NOTE: MODIFICATION FOR REMOTE OPERATION

QTY. REQ.	ITEM	PART NO.	DESCRIPTION	SYMBOL
LIST OF MATERIAL				
FINAL APPROVAL: <i>[Signature]</i> DATE: 2-18-69 MECH. DES. DATE: ELECT. DES. DATE: 2-17-69 CHECKED: <i>[Signature]</i> DATE: 2/16-69 DRAWN: C. Grob DATE: 4/6/68				
THE TECHNICAL MATERIEL CORP. MAMARONECK, NEW YORK MODIFICATIONS OF TR4 FOR REMOTE CONTROL OPERATION				
MATERIAL		SIZE	CODE IDENT. NO.	DWG NO.
FINISH		C	82679	CK8080
		SCALE	γ	SHEET 1 OF 1

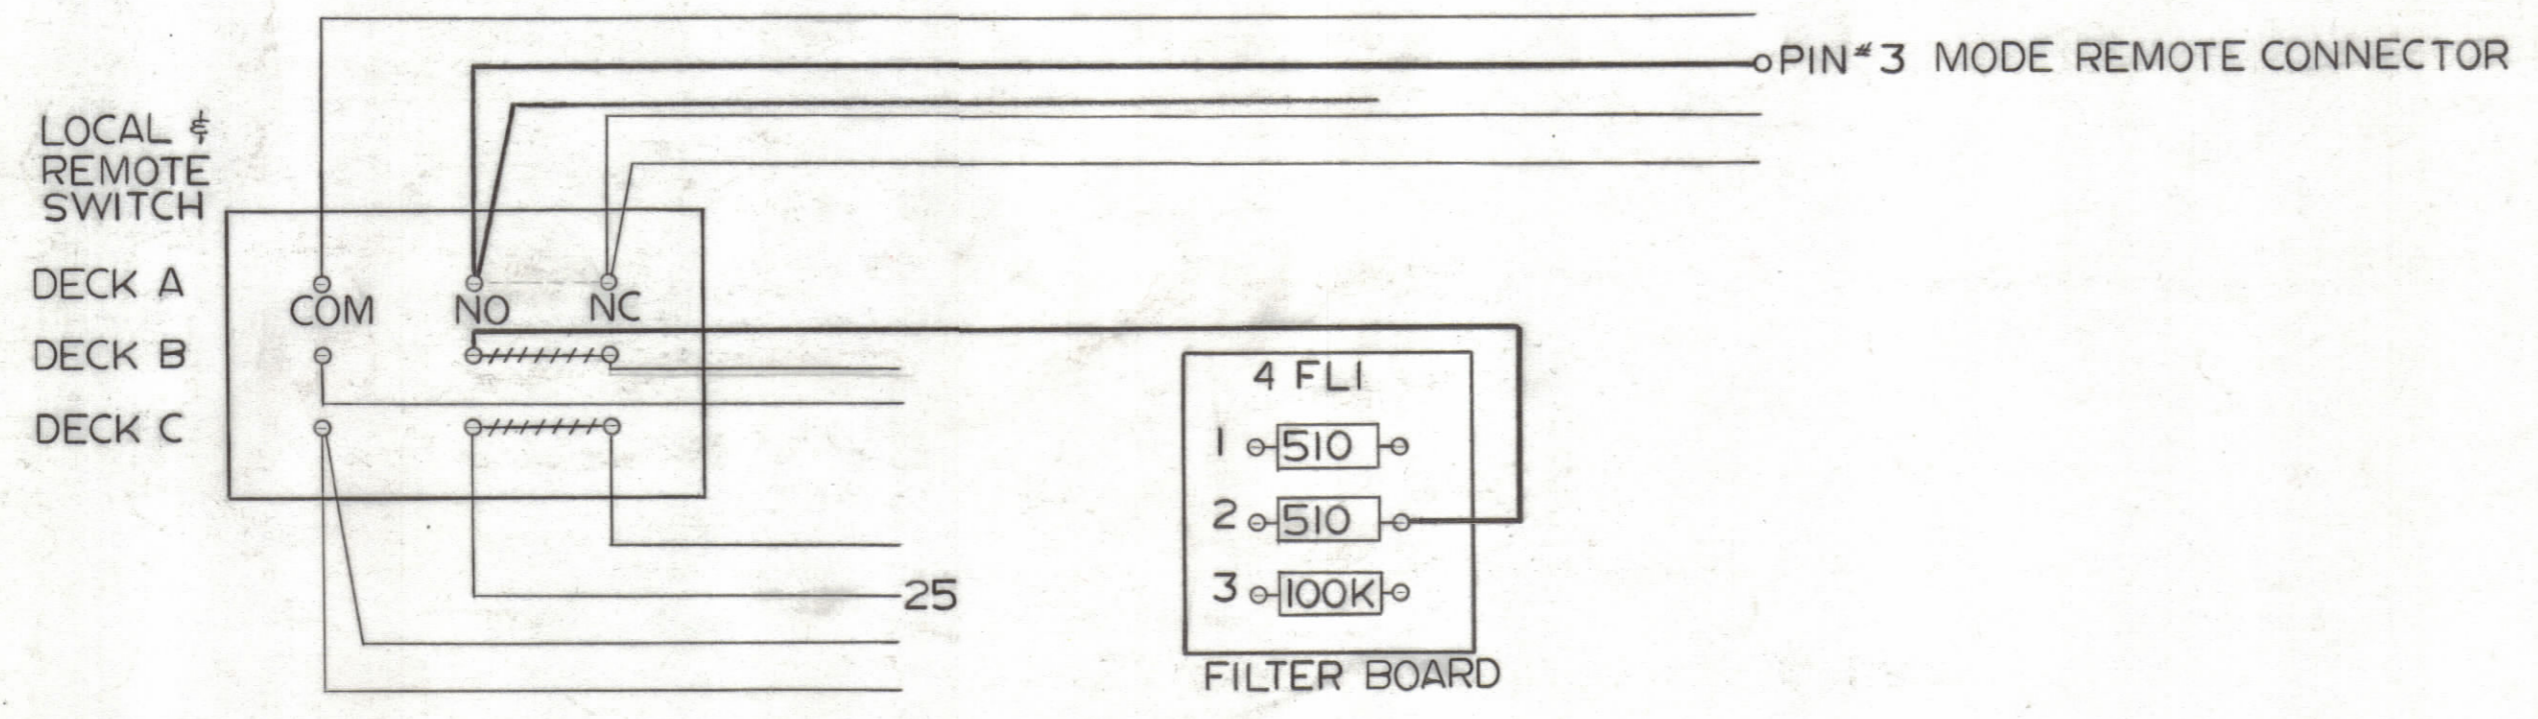
- NOTES:
1. REMOVE 2 JUMPERS MARKED //
  2. PULL OUT 2 WIRES FROM HARNESS
  3. WIRE FROM MODE REMOTE CONNECTOR PIN #3. SOLDER TO DECK A N.O.
  4. ADD WIRE FROM FILTER BOARD 4FLI TO THE SECOND 510-ohm RESISTOR TO DECK (B) N.O.
  5. MODIFICATION INFO PROVIDED BY RCA.

WIRES ADDED, SHOWN —————  
 JUMPERS REMOVED, SHOWN - - - - -
